GENERAL ELECTRIC COMPANY VALLEY FORGE SPACE CENTER
(MAIL: P. O. BOX 8555, PHILADELPHIA, PENNSYLVANIA 19101), Phone (215) 962-2000

September 12, 1978

Ref: File Code 90088

The items below refer to Mr. Paul R. Guinn's letter of May 24, 1978. These responses are based on discussions among Mr. R. G. Oesterling of General Electric Company and Messrs. Guinn and Basson and Ms. Tremper of NRC on July 18, 1978.

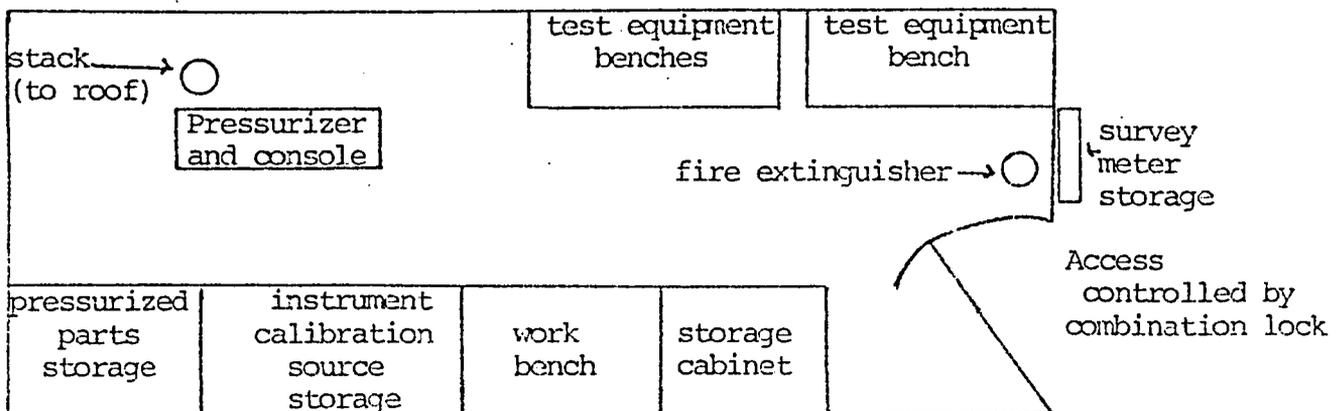
In the meeting of July 18, 1978, it was indicated that a sketch of one example of a facility would be a sufficient response. The sketch below is of a facility for leak-testing electronic components using a Trio-Tech (TM) pressurization device. The sketch is not to scale. This facility utilizes approximately 12 curies of Kr85.

The exhaust system is on uninterruptible power the exhaust stack terminates at 1.3 times the building height as recommended by the ACGIH. The stack monitor and exhaust flow alarm in the Plant Protection Center.
